DATE: 10/08/2026
TO: All Bidders
FROM: David Cienfuegos, Purchasing Specialist
SUBJECT: Addendum 1 – Bid 738 Moorpark College Student Service Building Sewer Line Reroute

Attached please find revised plans for this project, P2 and P2A.

SCALE: AS SHOWN	STUDENT SERVICE ANNEX SEWER RE-ROUTING PROJECT	SHEET NO.
DATE: 7-16-26	SEWER SITE PLAN (ALTERNATE)	P2A 2 OF 2
BUDG. NO.

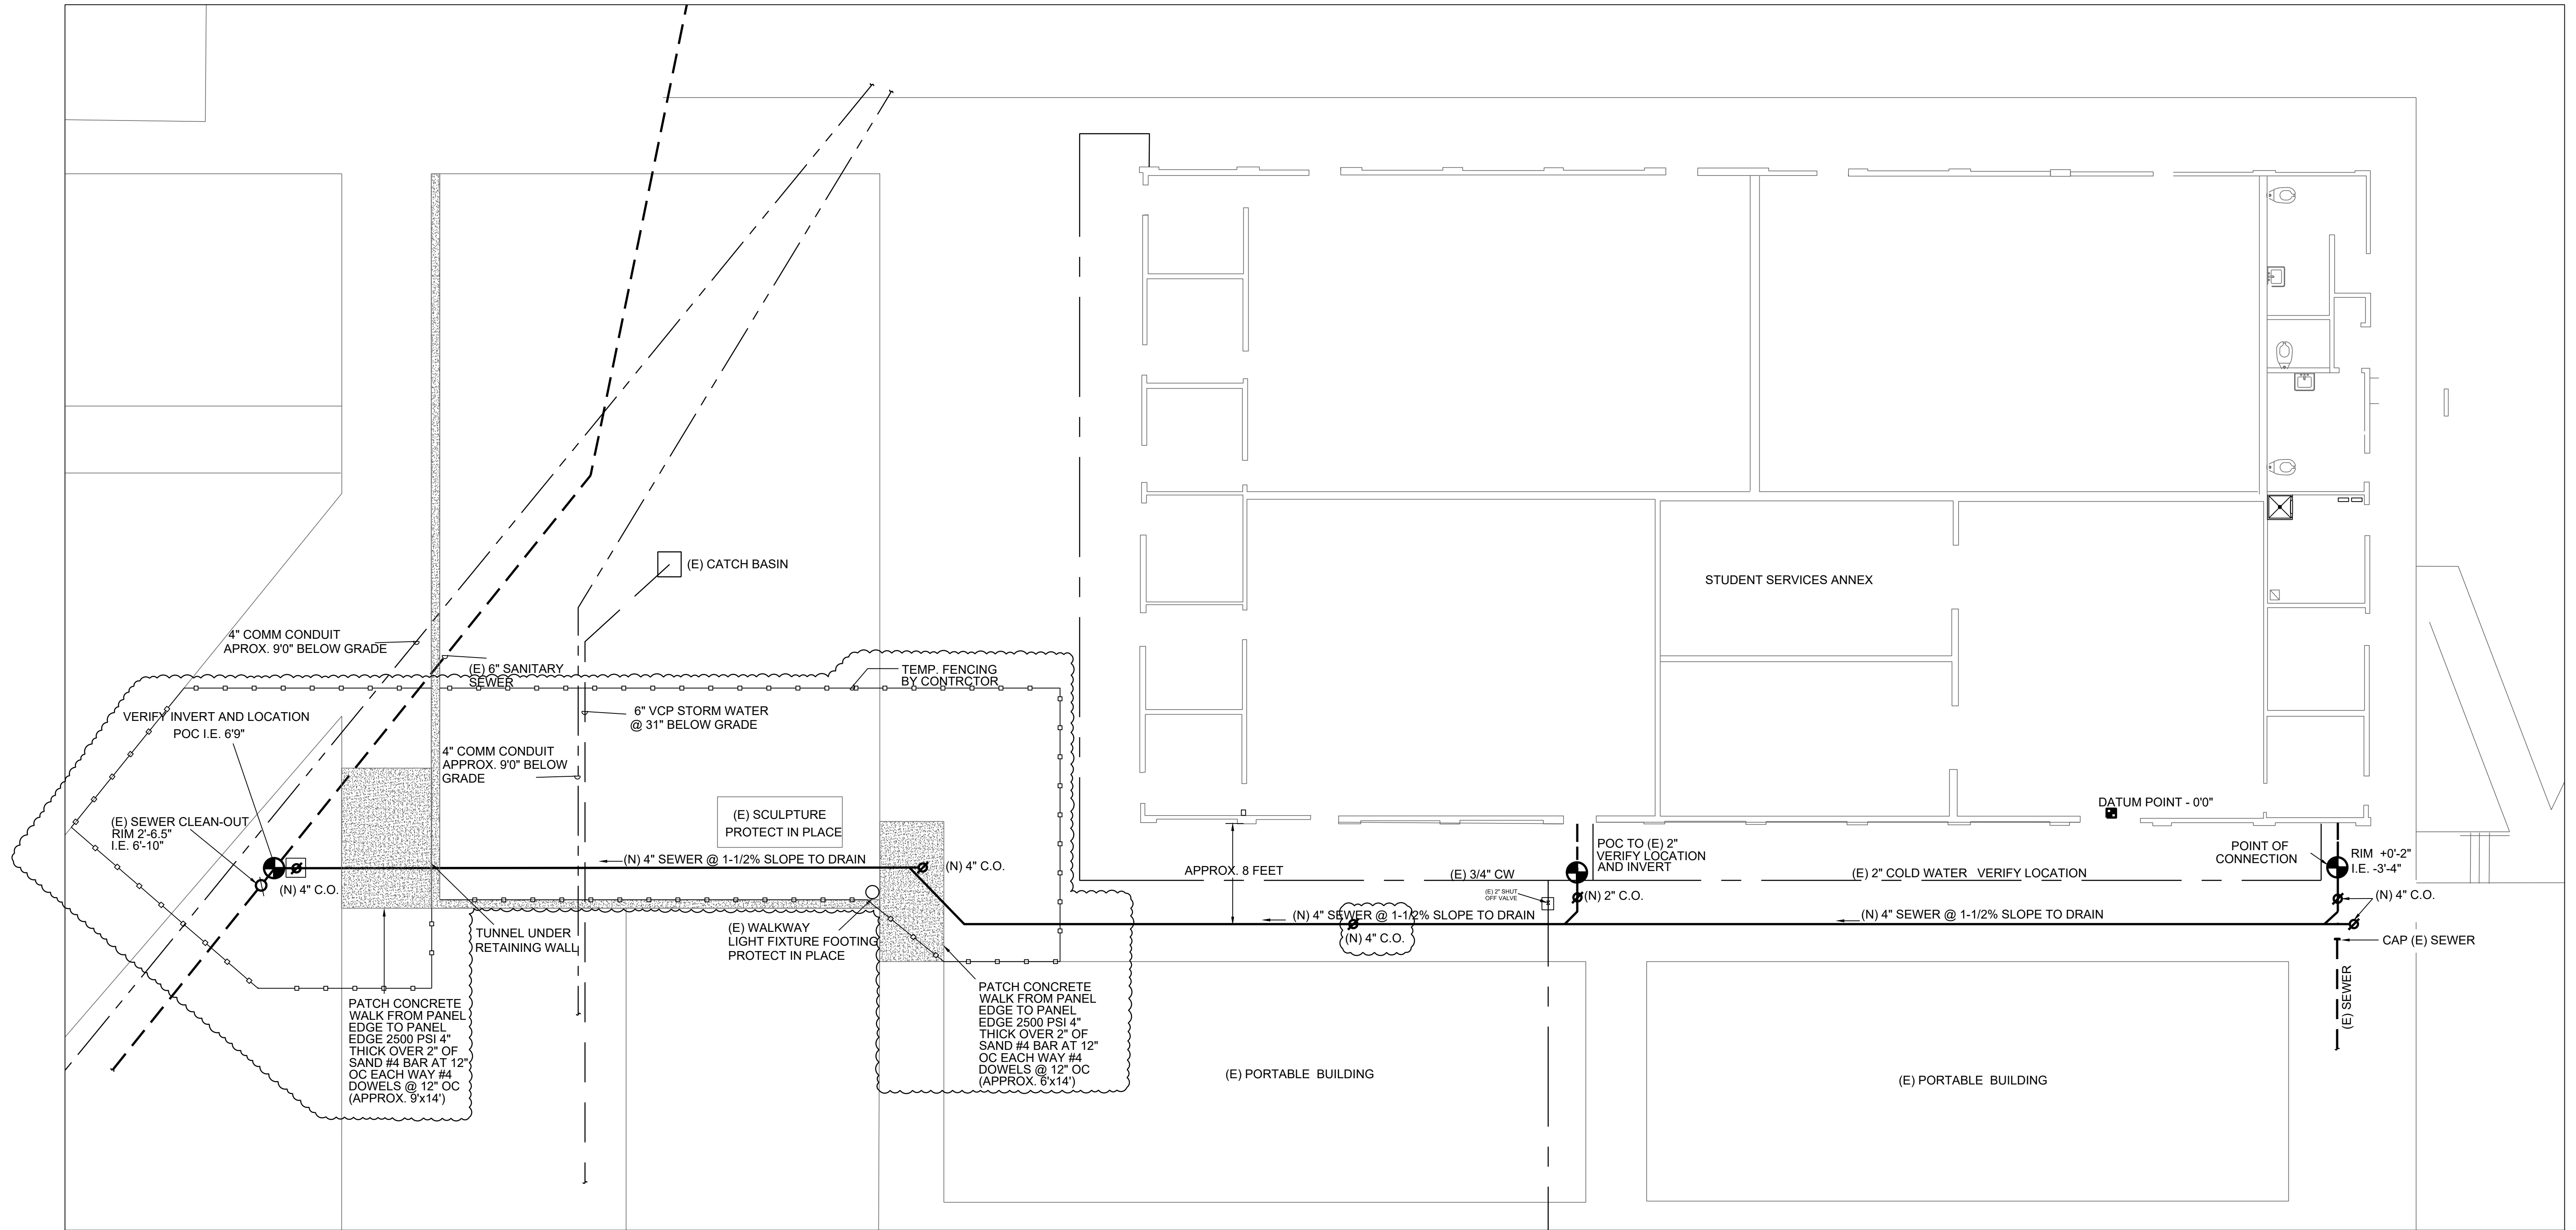
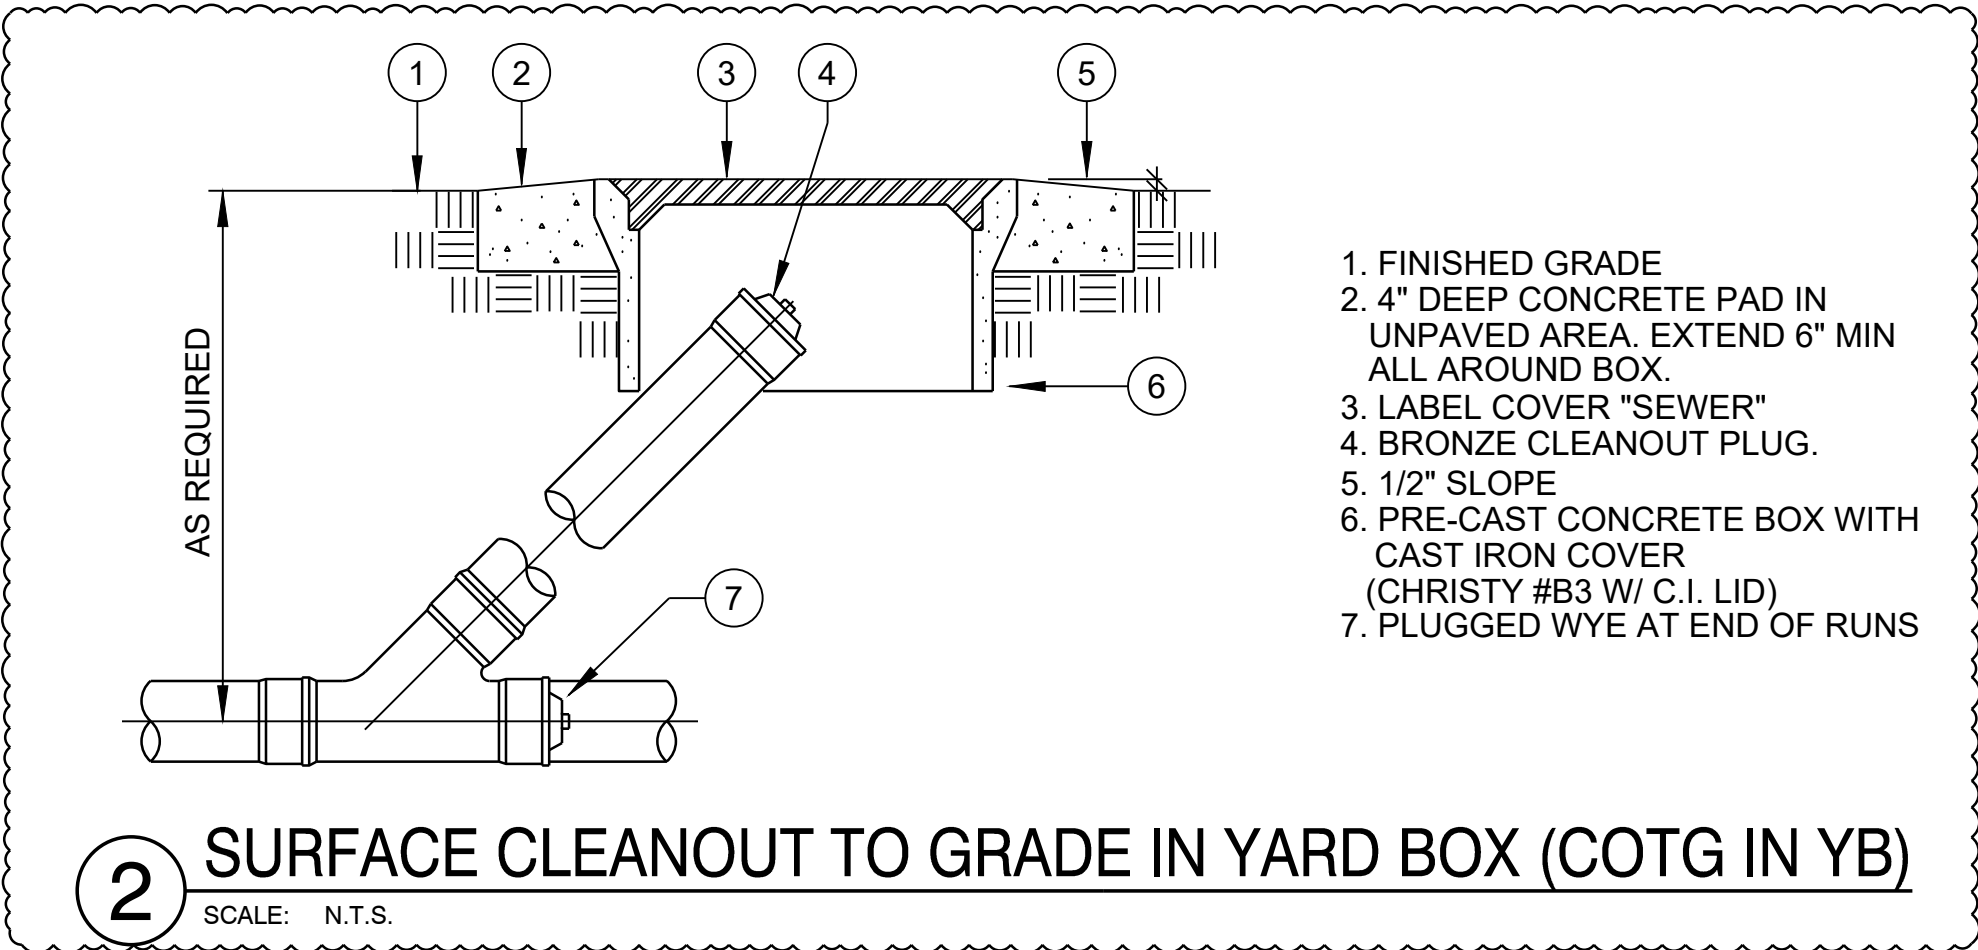
1. Who is responsible for removal and replacement of concrete – which areas and how much?
 - a. Some Bids 738 and some on Bid 739. Please see P2 and P2A for concrete replacement areas in Bid 738.
2. Additional cleanouts to be installed?
 - a. Yes, there will be additional clean-outs clouded on the attached sheet.
3. Awarded contractor responsible for fencing?
 - a. Bid 738 Contractor will be responsible for fencing protection at the areas shown on P2 & P2A.

9. Size of panels to be replaced?
 - a. Please see P2 and P2A for approximate size of the concrete panels. Panels shall be replaced from control joint to control joint. Contractor to field measure actual size of panels. At walkway with brick perimeter, use similar color concrete paver and trim bull nosing on four sides to match size of existing brick.

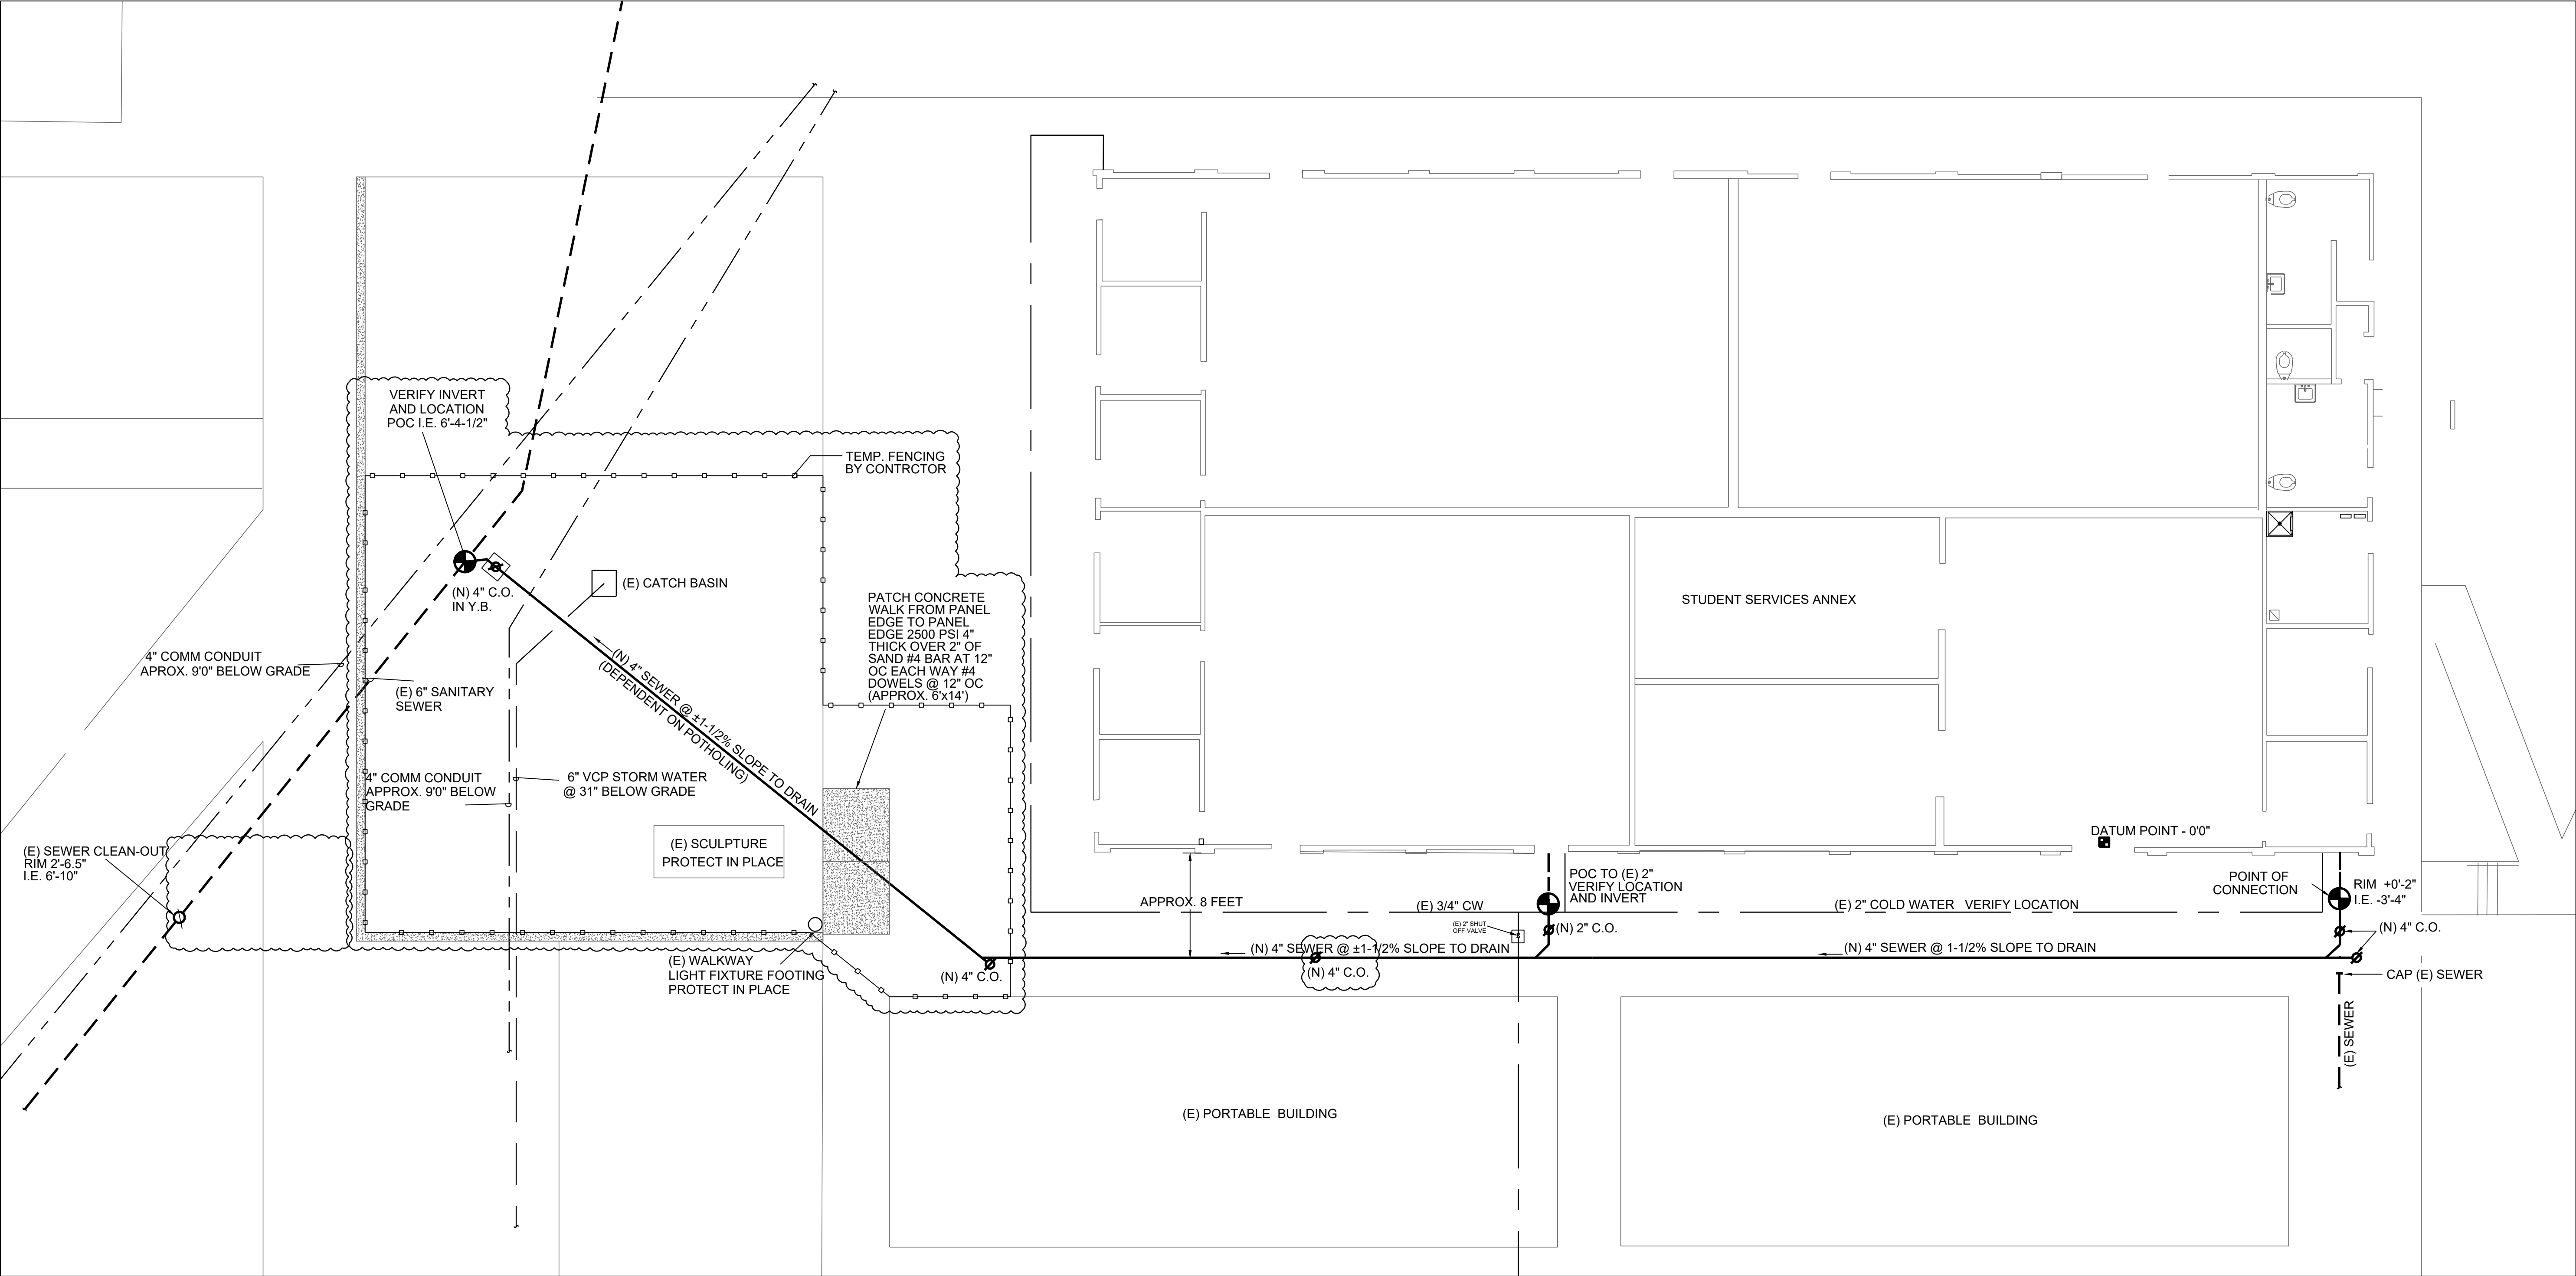
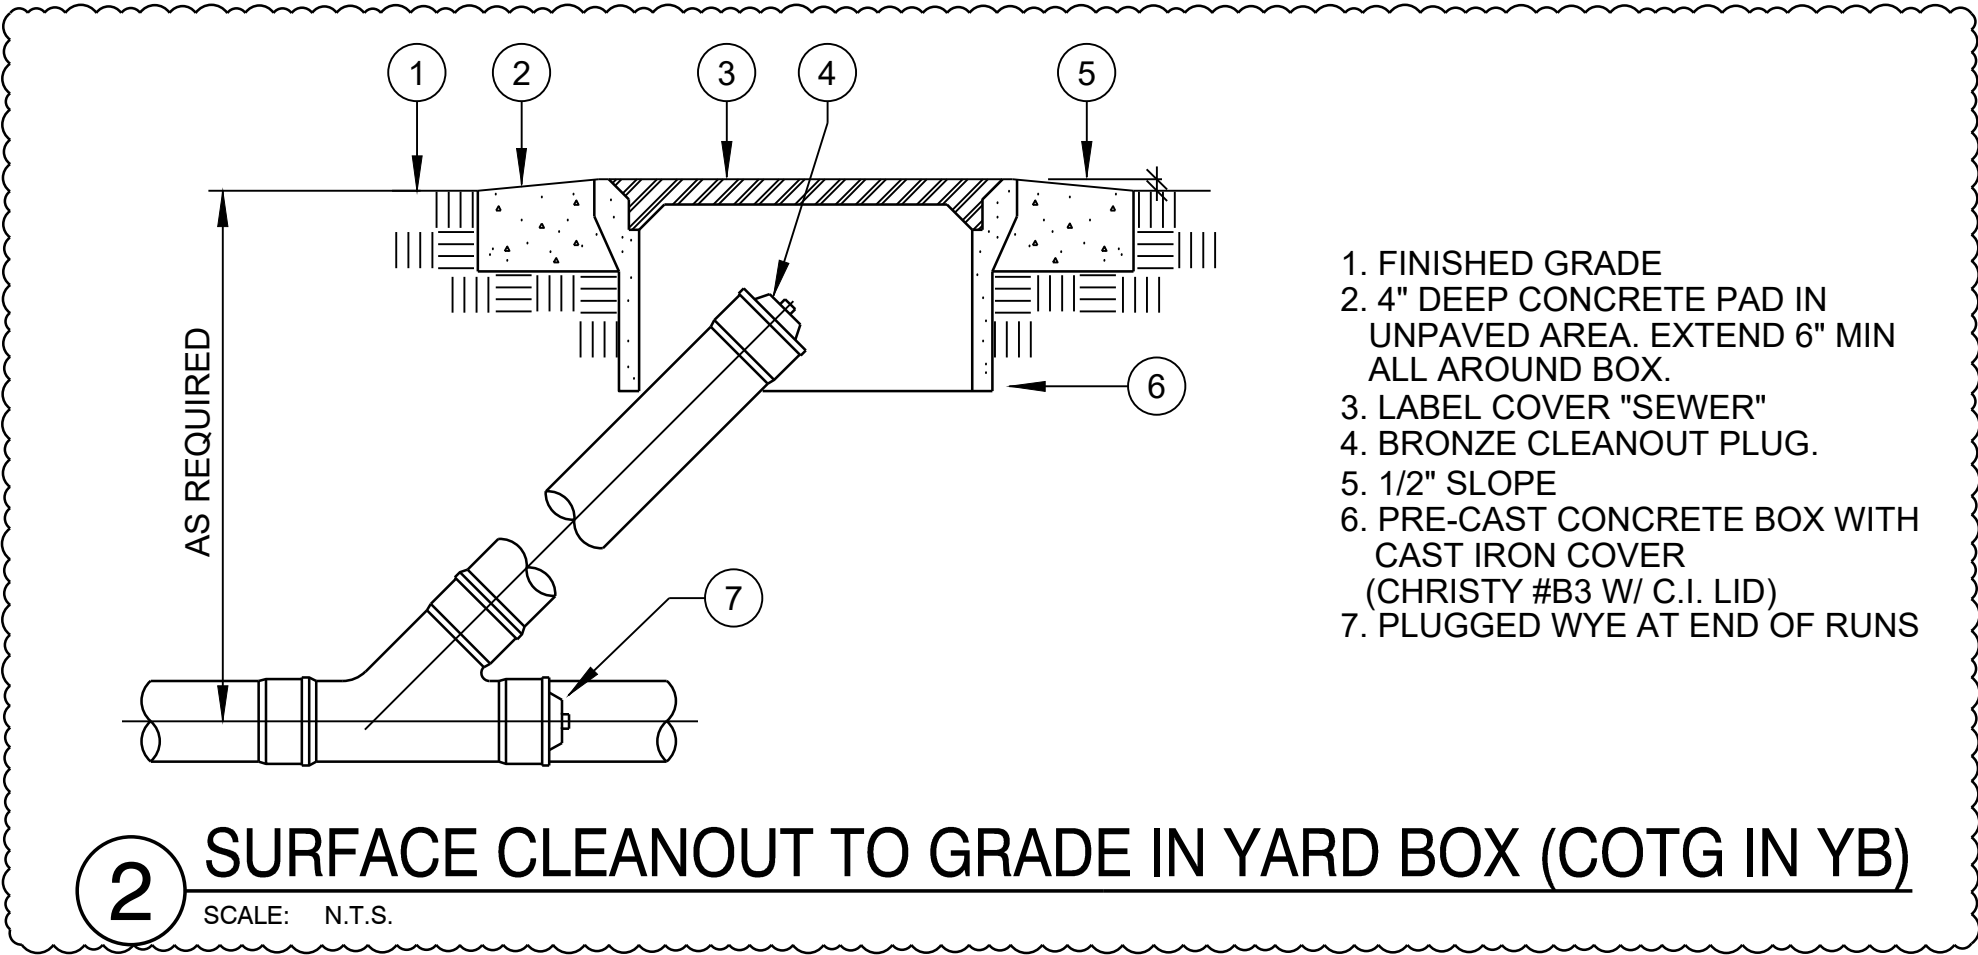
12. Potholing and marking utilities – who is responsible?
 - a. Campus will mark utilities at the start of the project. Bid 738 Contractor is responsible for potholing. At the start of construction, Contractor shall pothole to determine if the alternate P2A path is feasible. Provide surveyed inverts based on common datum point to engineer with proposed sewer slope on simple shop drawings with distance prior to trenching and laying pipe.
